Whipple Consulting Engineers, Inc.

**Re: Response to Determination of Incompleteness
Crestview Estates – A Residential Short Subdivision and Replat**

This letter is to confirm receipt and respond to the determination of incompleteness for the Crestview Estates Preliminary Short Plat, City of Spokane file number Z22-423PSP. For clarity, City of Spokane and agency comments are listed below and in italic type, and our responses are in roman type (upright).

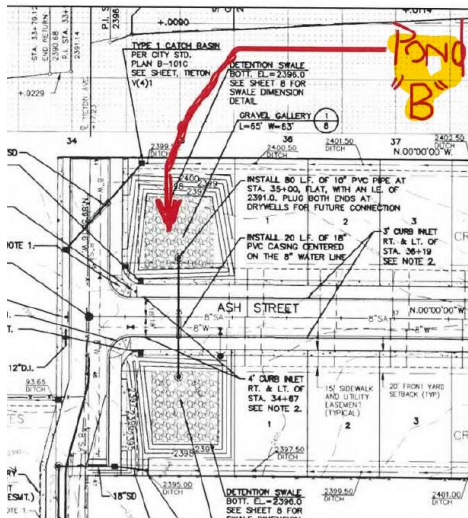
- c. *In the first paragraph of the pre-development basin information, please clarify what is conveyed (“Per the original civil engineering plans in 2003 the is conveyed to two...)*

WCE Response: The first paragraph of the pre-development basin information section has been corrected to state that “the *stormwater* is conveyed to two...”. The updated report contains information that would be expected to accompany civil drainage plans.
